ADDENDUM NO. 3

February 6, 2023

**SOLON ROBINSON ELEMENTARY SCHOOL ADDITIONS,
RENOVATIONS, AND RELATED WORK
Crown Point, IN 46307**

A-404

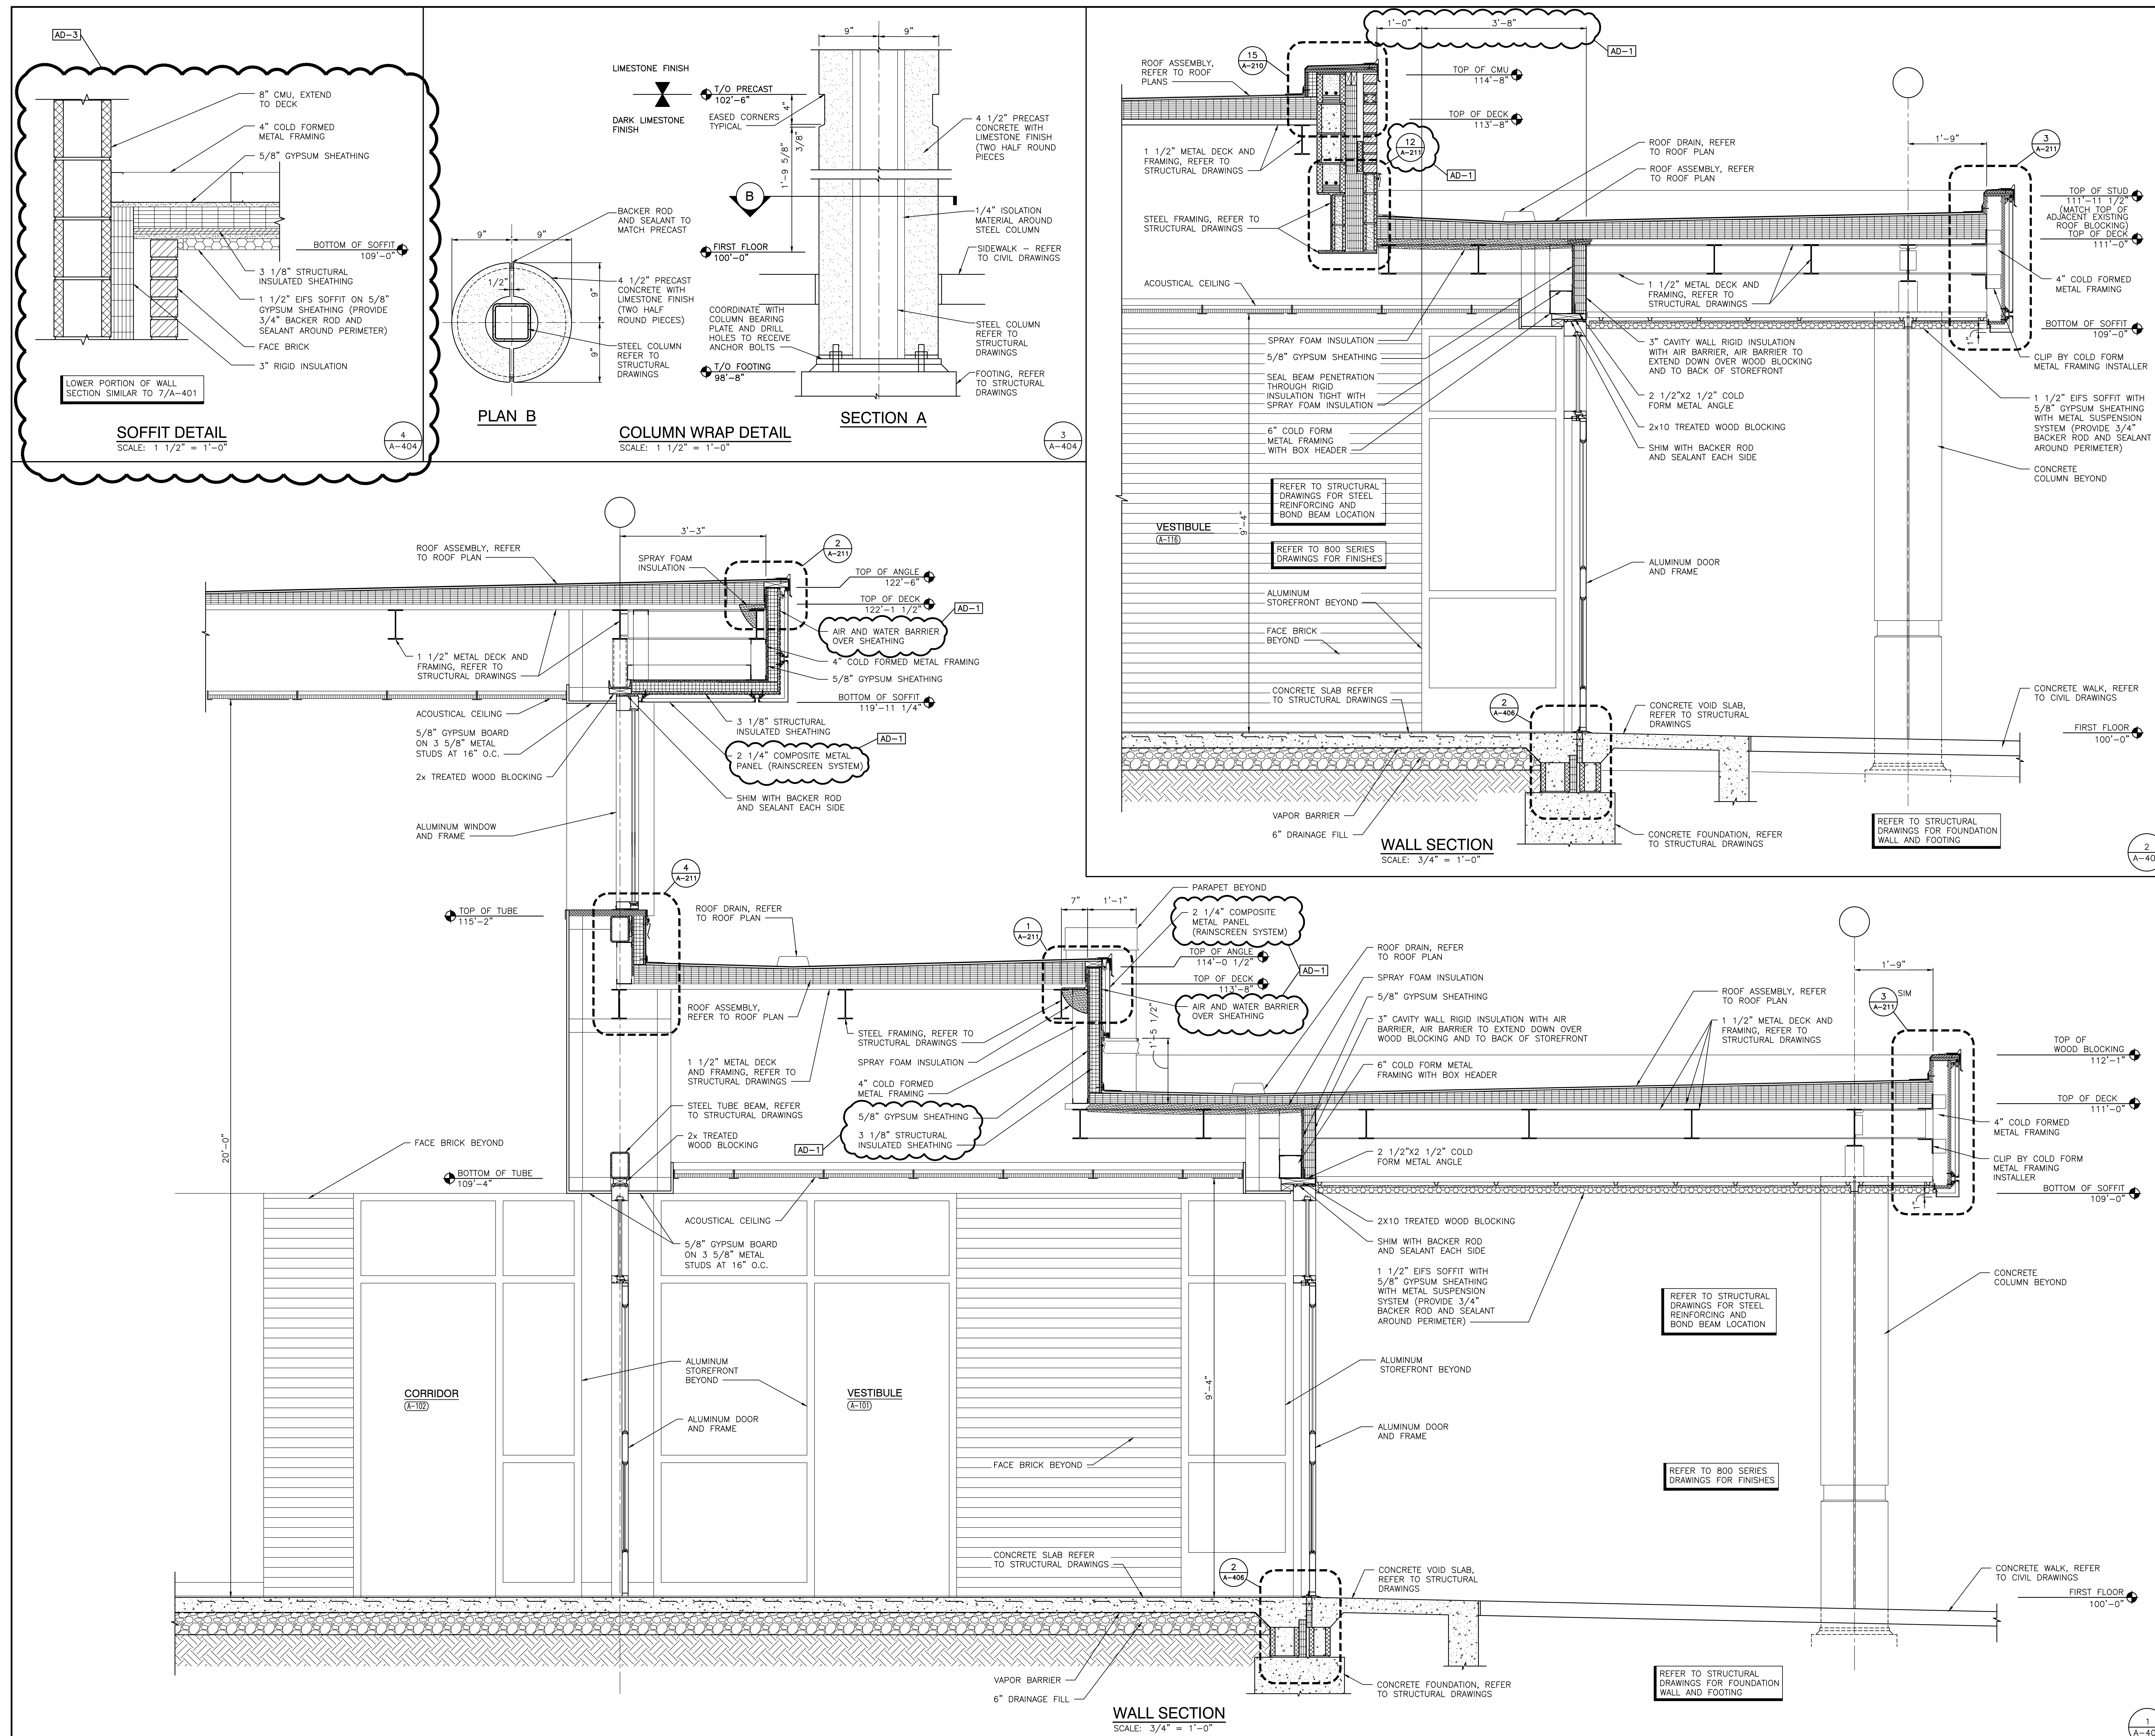
- A. Add new Soffit Detail 4.

A-502

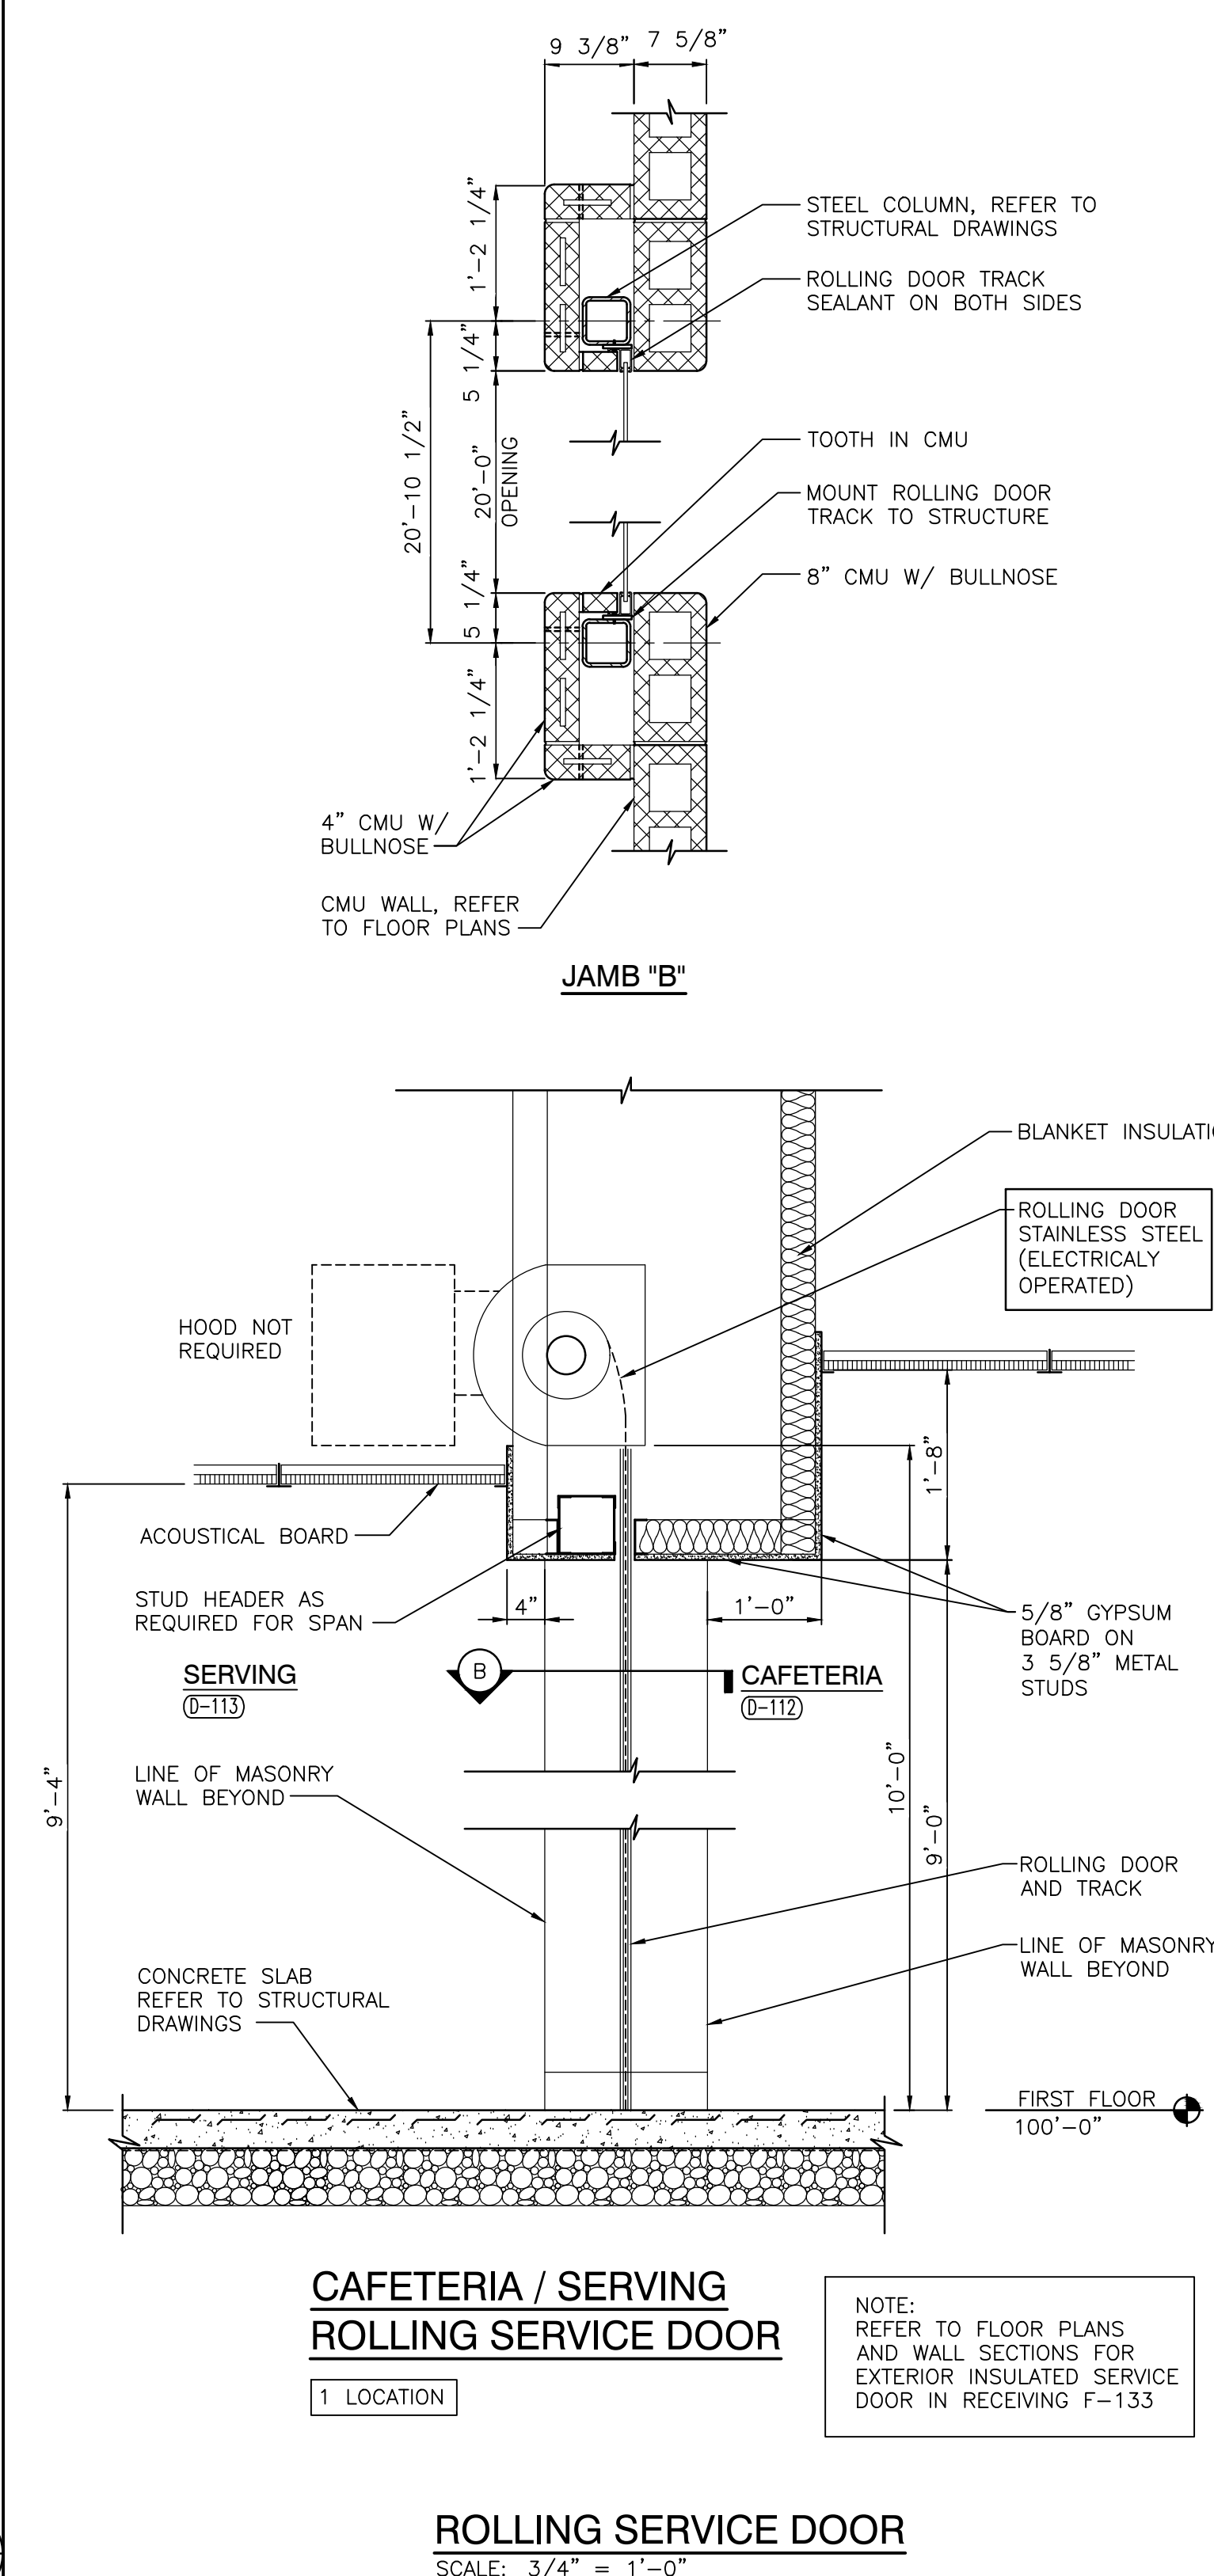
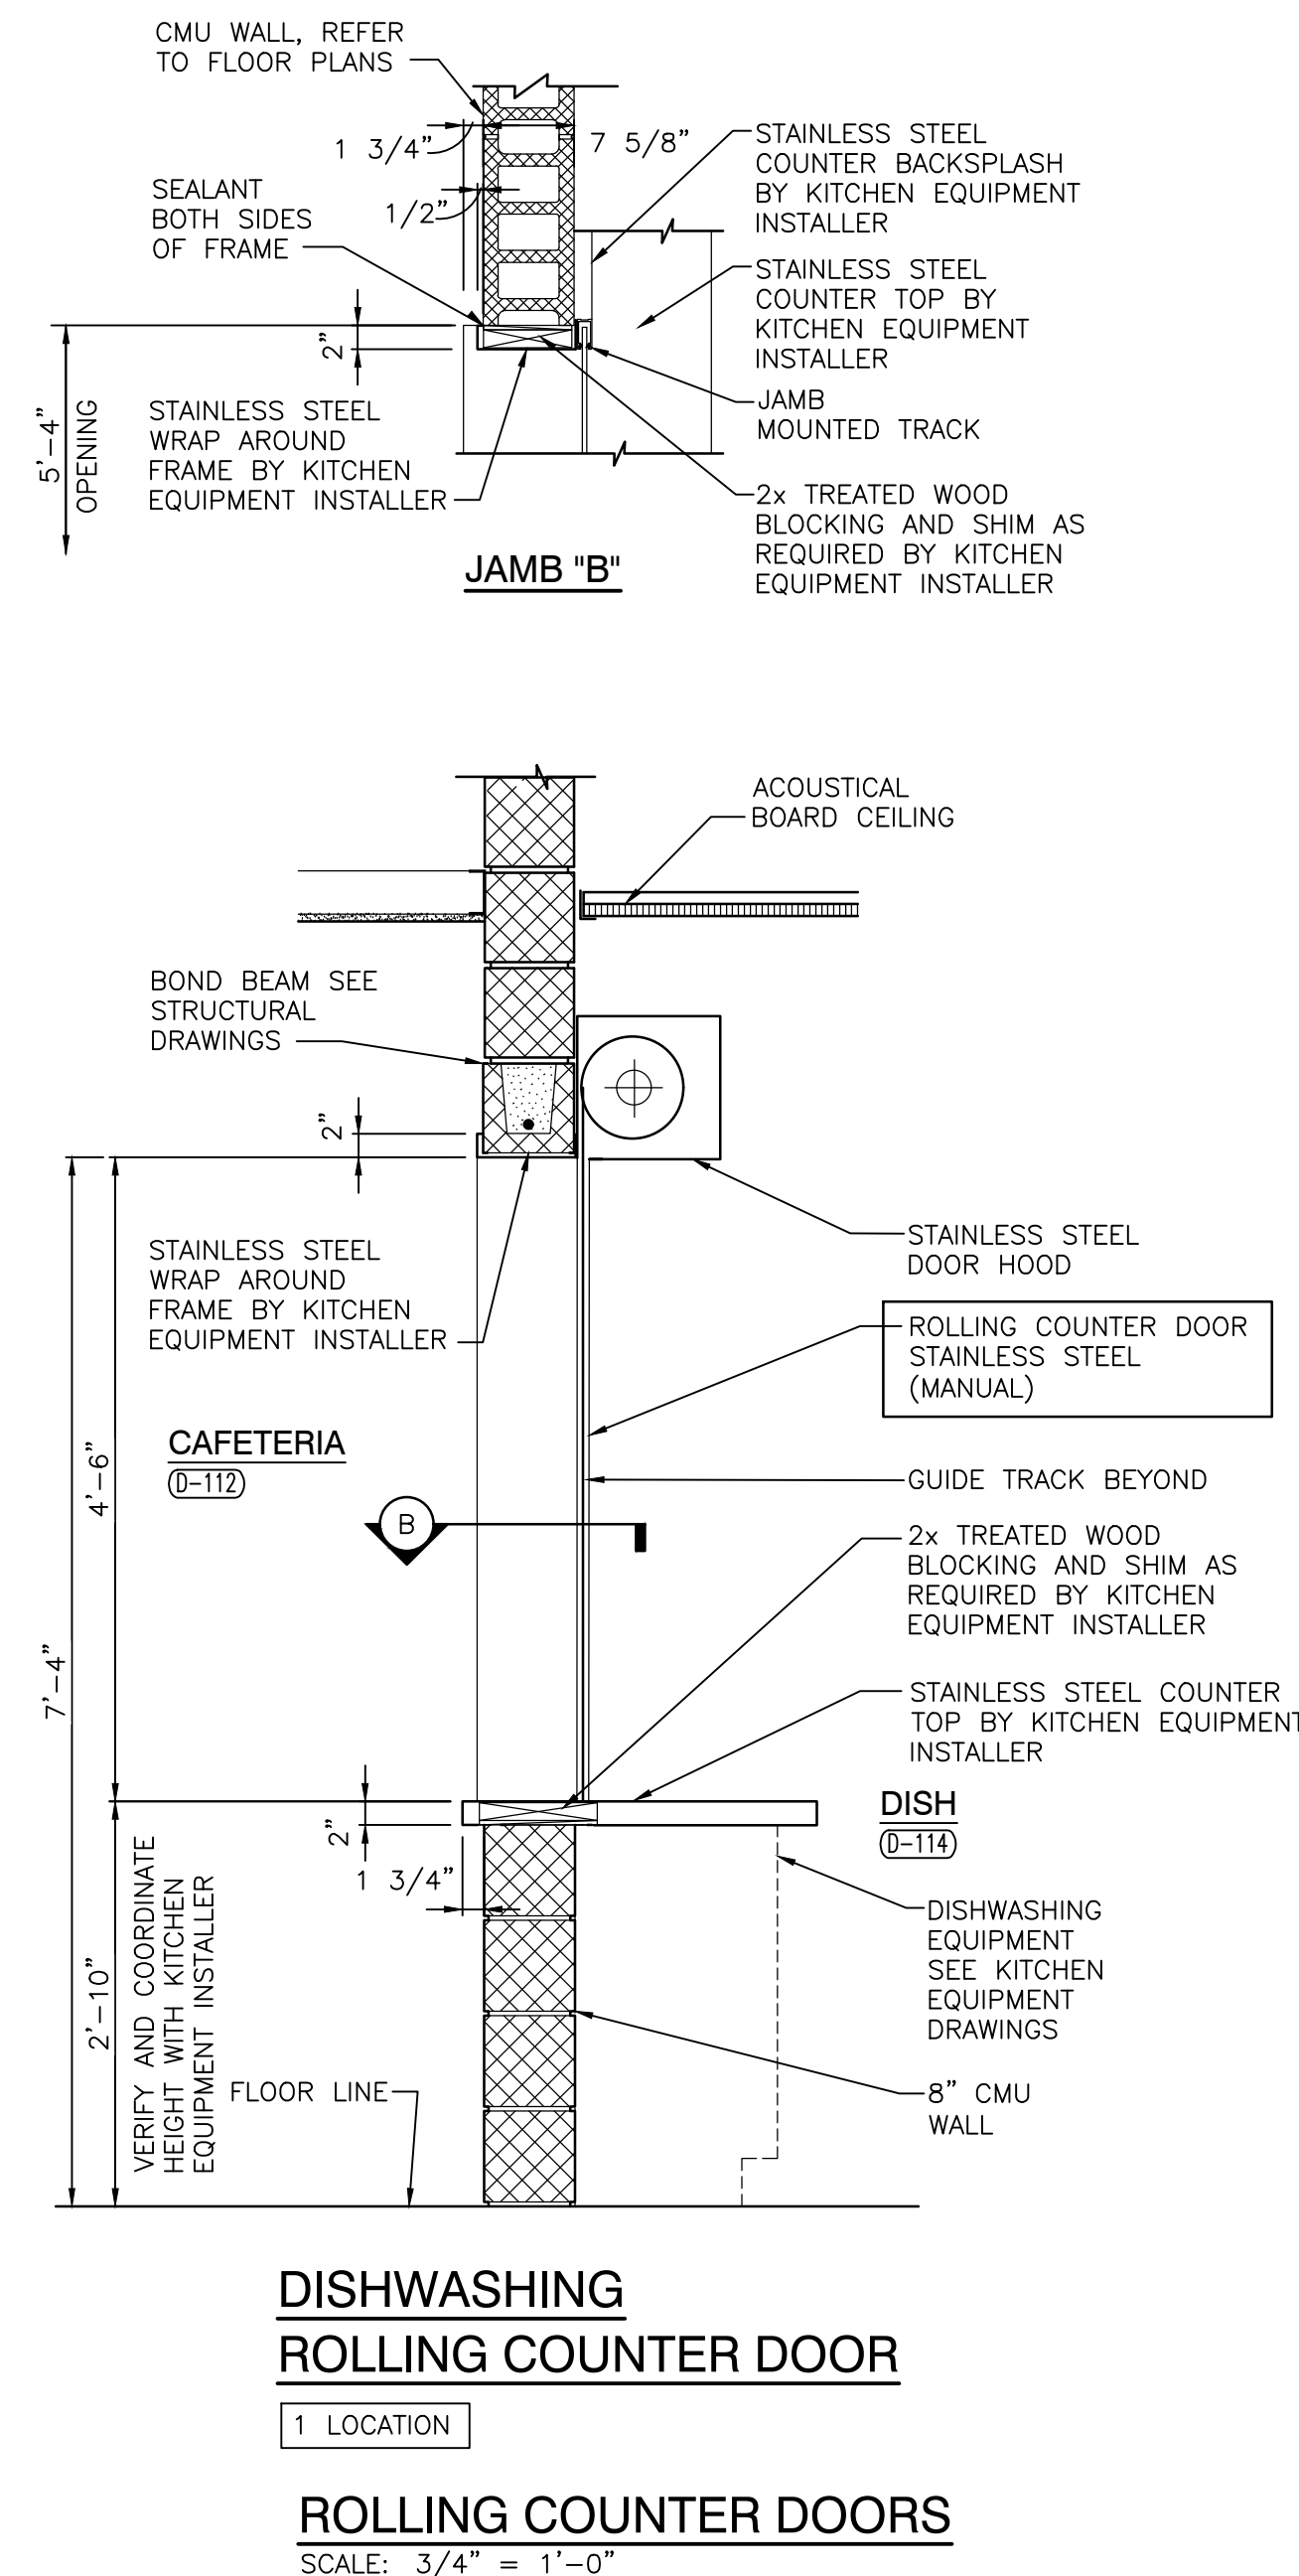
- A. Add new Grille Detail 5.
- B. Marker/corkboard Elevations 3: Revise Notes.
